WD-SD Flood Ops manual - Response to Ron Guppy's Comments

Response to NRMW Comments to Version 7 of Manual

Revised Interaction Diagram

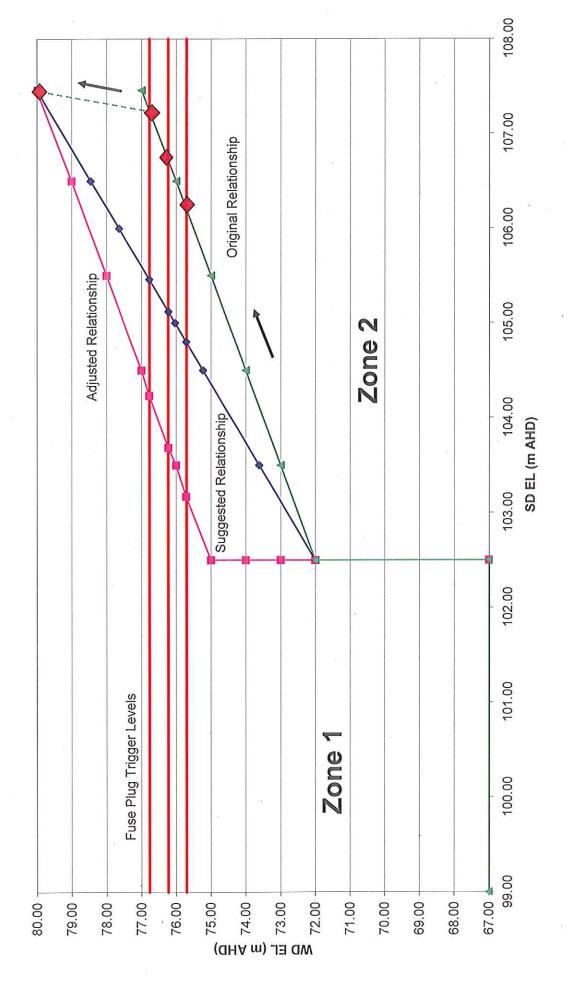
• The water level correlation targets in the Somerset Dam procedure (section 9.4) have been changed apparently in recognition of the 'safe' peak water level in Wivenhoe Dam being increased from EL77 to EL80. Can some comment be provided, separate to the procedures document, in support of the change. This probably means outlining the effects of the change. I'm not sure that the proposed changes are for the better.

It is acknowledged that the change incorporated into the manual actually increases the likelihood of the first fuse plug initiation when compared to the current values (i.e previously EL75.7 and EL106.1, now suggested as EL75.7 and EL104.8). Refer to the attached figure.

The correlation targets originally attempted to match freeboard – raising the Wivenhoe maximum flood level means that a given level in Somerset will now correlate with a higher level in Wivenhoe. If the freeboard criteria was applied this would further increase the likelihood of the first fuse plug initiation (EL75.7 and EL103.2). The suggested relationship was proposed to take advantage of the increased flood storage now available in Wivenhoe Dam, whilst not wanting to increase the likelihood of the initiation of a fuse plug.

It is recommended that these correlation targets be reassessed taking into account the fuse plug triggers. In general a higher level in Somerset should be correlated with the levels in Wivenhoe when each fuse plug is initiated. An example set of targets are shown in the table below, although the exact figures require further investigation. In particular, assessment of the risk of storing more water in Somerset needs to be performed.

The table below shows a possible modification to the original relationship that could also be followed. This is shown as the red diamonds in the accompanying figure. The trade off with this approach is the reduction in freeboard at Somerset dam after the third fuse plug initiates. (i.e. only 0.31 m between the trigger level of fuse plug 3 EL107.15 and the maximum design level of Somerset dam EL107.46).

The change to the water level correlation targets reflects the new maximum design peak flood level of Wivenhoe Dam (EL80).

The alteration to the target levels is based upon the adjustment the final duty point to EL80 and EL107.46. The main issue is how to progress to this final point when considering the introduction of the auxiliary spillway trigger levels.

Note these are target points, not a target line. The path to each point is not critical, as long as each decision on Somerset gate openings move towards the next point. For example, if modelling indicates that Wivenhoe will reach EL75.7 before Somerset reaches EL106.1, then gate/s should be closed on Somerset.
